PD Modification Application: PRS 26-0617

The applicant is requesting a minor modification to add an optional stub out point to the southern boundary, which could allow a connection to Bishop Road. No changes to the entitlements are proposed.

AGENCY REVIEW COMMENT SHEET

2.4 Proposed Site Plan (partial provided below for size and orientation purposes. See Section 8.2 for full site plan)

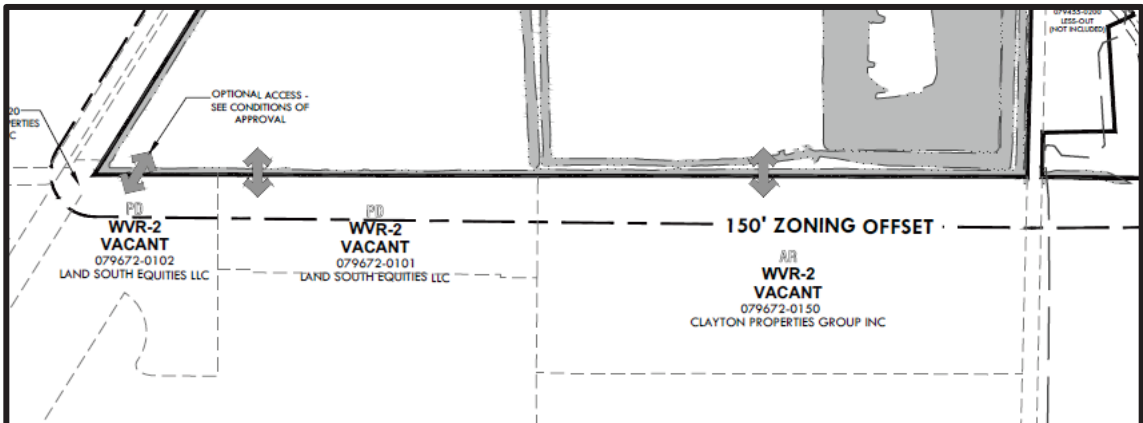
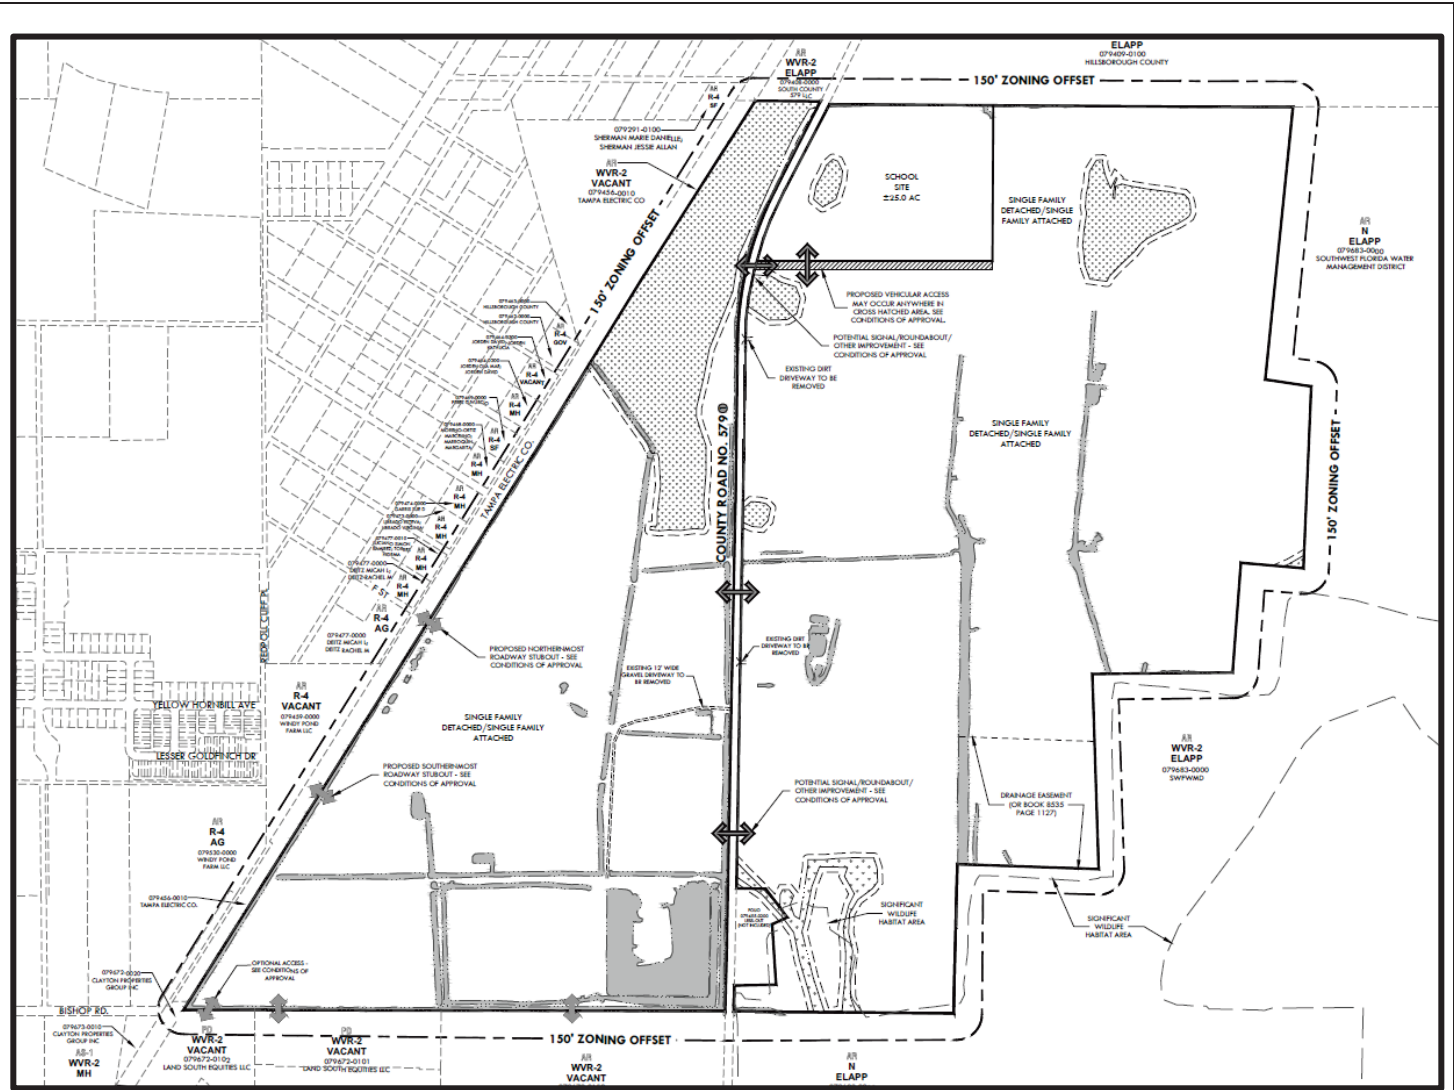
- Two stub out points, plus an optional stub out point along the southern boundary.

--Western Boundary--

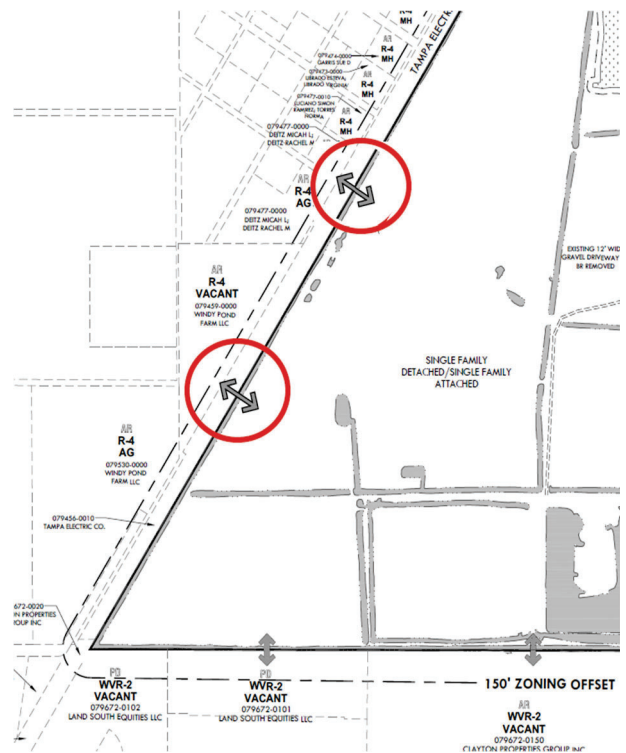
Along the project's western boundary (within the Western Development Area), which is approximately 6,290 feet in length, there is an abandoned railroad corridor now owned by the Tampa Electric Co. (TECO). Area planning efforts have been based on Sec. 6.02.01.A. of the LDC and guided by the requirement of 1,320 feet access spacing as provided for within the Wimauma Village Community Plan (WVCP). This would suggest a total of four connections (rounded down from 4.76) would be required. Excluding the northernmost +/- 1,850 feet of the site, which is shown as wetlands/conservation on the PD site plan, a total of three connections (rounded down from 3.36) would be required. The developer is proposing two through road connections. The third connection was presumed to be the Bishop Rd.

--Southern Boundary--

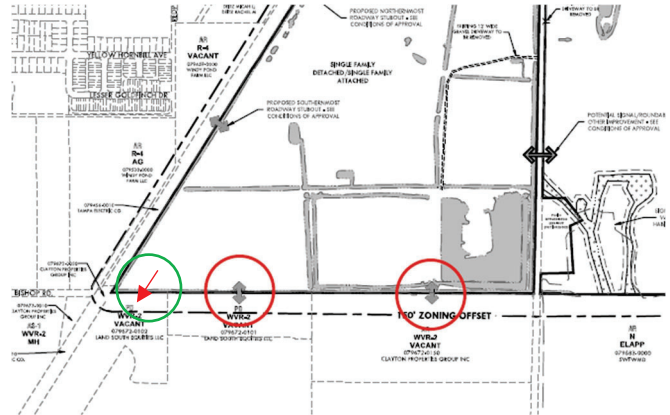
The southern property boundary is approximately 3,200 feet in length (between the TECO corridor and CR 579). Given the connection spacing standards, a total of two connections would be required (rounded down from 2.42).

The developer is providing two connections, in addition to the CR 579 north-south corridor, (for a total of three connections provided). Applicant-proposed through road connections are shown circled in red. An additional optional stubout along the southern boundary is being proposed as a part of this PRS (as further described herein above) which, if constructed, would result in a fourth connection.

--Western Boundary--

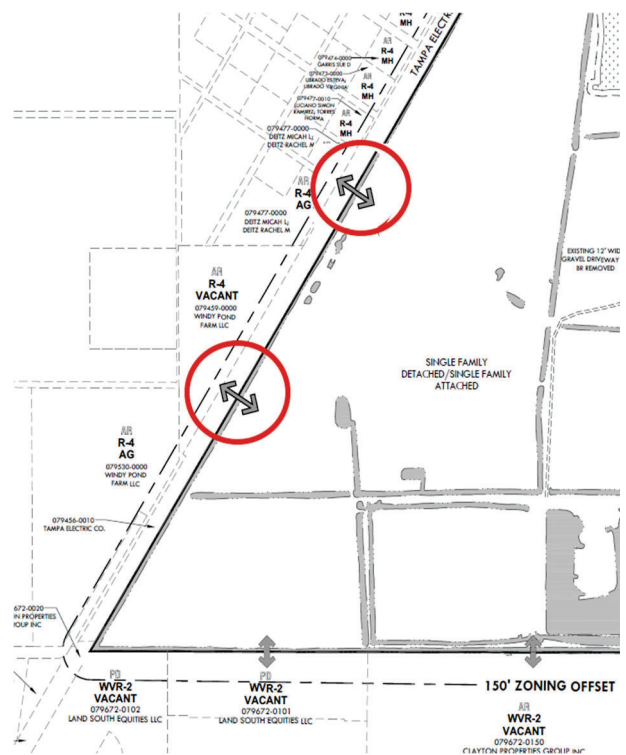
Along the project's western boundary (within the Western Development Area), which is approximately 6,290 feet in length, there is an abandoned railroad corridor now owned by the Tampa Electric Co. (TECO). Area planning efforts have been based on Sec. 6.02.01.A. of the LDC and guided by the requirement of 1,320 feet access spacing as provided for within the Wimauma Village Community Plan (WVCP). This would suggest a total of four connections (rounded down from 4.76) would be required. Excluding the northernmost +/- 1,850 feet of the site, which is shown as wetlands/conservation on the PD site plan, a total of three connections (rounded down from 3.36) would be required. The developer is proposing two through road connections. The third connection was presumed to be the Bishop Rd.

--Southern Boundary--

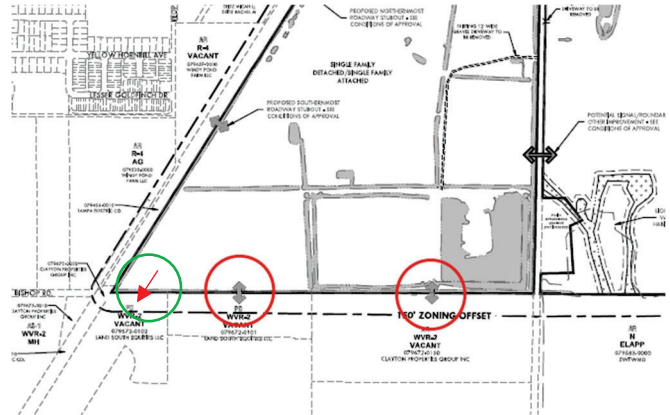
The southern property boundary is approximately 3,200 feet in length (between the TECO corridor and CR 579). Given the connection spacing standards, a total of two connections would be required (rounded down from 2.42).

The developer is providing two connections, in addition to the CR 579 north-south corridor, (for a total of three connections provided). Applicant-proposed through road connections are shown circled in red. An additional optional stubout along the southern boundary is being proposed as a part of this PRS (as further described herein above) which, if constructed, would result in a fourth connection.
